: MOUNTING BRACKET

Process Sheet

DESIG	#	DRAWN BY	DART AEROSPACE LTD HAWKESBURY, ONTARIO, CANADA	
CHEC	KED	APPROVED	DRAWING NO. REV	v. B
1	#	#	D2053 SHEET 1 C	OF 1
DATE			TITLE SC	CALE
02.0	03.12		BRACKET	1:1
A		92.01.12	NEW ISSUE	
В		02.03.12	Ø0.635 WAS Ø0.437; 0.635 WAS 0.32	5

Subject: RE: D206-558 -> D2053 Bracket

D2053 FLAT PATTERN

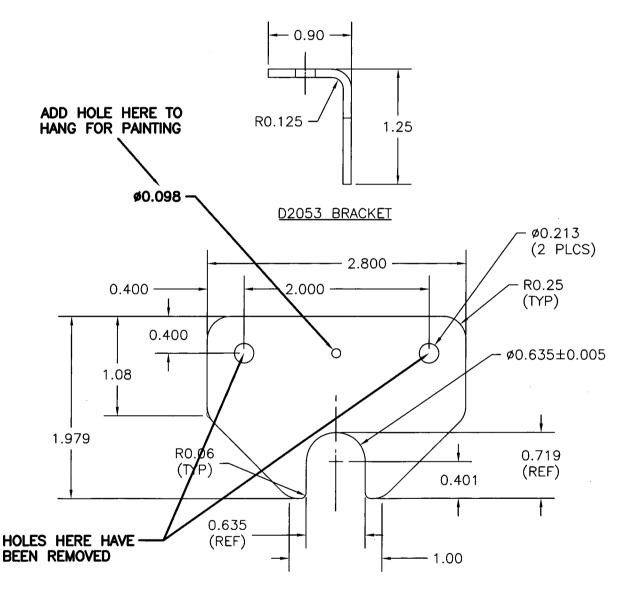
Per our phone conversation, I have clarified the location of the 0.098" hole (see attached) to be added. As previously discussed, the 0.213" holes are removed and will be drilled by the customer.

It seems like the last production of these parts had a 0.098" hole drilled on the centerline to allow the finishing to hang the piece for powder coating. However, the last work order has been misplaced.

Therefore, is it acceptable to drill the 0.098" hole as shown in the attached sketch? Chris or myself does not have delegation to sign off this change.

Recommend making parts without holes from now on.

Roberto put it under review and he added this note: "Ø0.213 may come out? Check with David".

The instructions to install the D2053 bracket indicate to pick up on existing nut plates (see page 4, note 3) but it is not specified whether the installer is required to drill holes through D2053 or not. I'm assuming that the holes must be there already.

As discussed, the changes are accepable for the batch that is being made.

Can we update the drawing right away to match production? This is the second time I've had this request. I got the first request several months ago from Marc.
